Product Highlights

- The CB series of Back-lit Collimated Backlights deliver precision silhouetting for a range of machine vision applications.

Change Notice

PCN No: 170

PCN No: 152

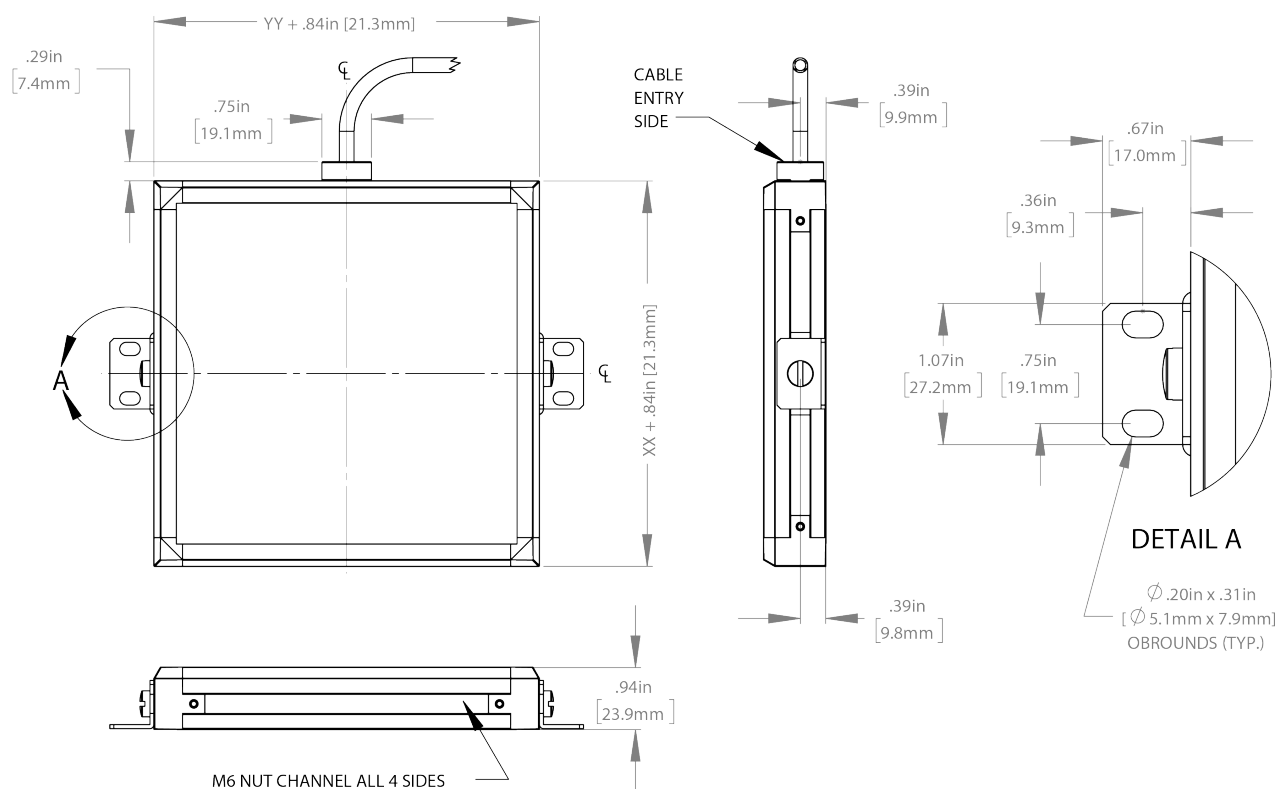
In an effort to improve our products, Advanced illumination (Ai) will be updating the internal drivers and white LEDs used in the BLXXYY, CBXXYY, FDXXYY, BL128, BL193, and BL245. This change will result in white lights seeing a brightness increase of roughly 70% while maintaining equal pricing for small configurations and reduced pricing for large configurations. Excluding the BL128, 24V configured units will experience a current draw shift from 20mA to 30mA per sq. inch for 470nm, 520nm and white units while controller configured units will see a current draw shift from 15mA to 18mA per sq. inch for the same color configurations. Color temperatures will remain unchanged.

The LED upgrade and internal driver update for white color configurations will take place September 15th. The internal driver updates will occur November 9th for 470nm and January 7th for 520nm.
